COMPILED MS COMMENTS

QF003	Document: Construction of houses – COP 10
-------	---

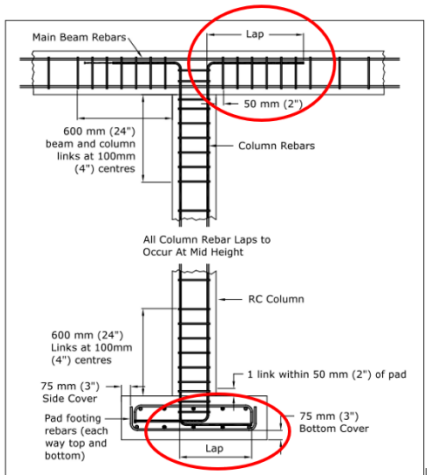
TT	Figure 6		te	Lap splices are not required in the circled regions. In fact, ACI recommends that at both “column to pad” and “column to beam” joints, the rebar should be curtailed towards the centroid of the column (if fixity is assumed). Lap splices are required to ensure rebar stresses are properly transferred between two adjacent rebar segments. In this application, rebar anchorage is more of a concern, ensue there is absolutely no requirement to enforce lap splices between column and beam reinforcement or even column and pad reinforcement. Section 5.1.13 of the COP document recommends a minimum lap splice of 50 bar		Understood, but this is our recommended design. Further, the laps can be achieved once the links (stirrups) are not fixed in place during the fabrication of the beam cage. If they are fixed, then the tie wire may be loosened and the links temporarily shifted out of the way. In the foundation, moments are expected	Accepted RPT Recommendation: Fig 6 to read....“Recommended design for Pad Footing and Columns”
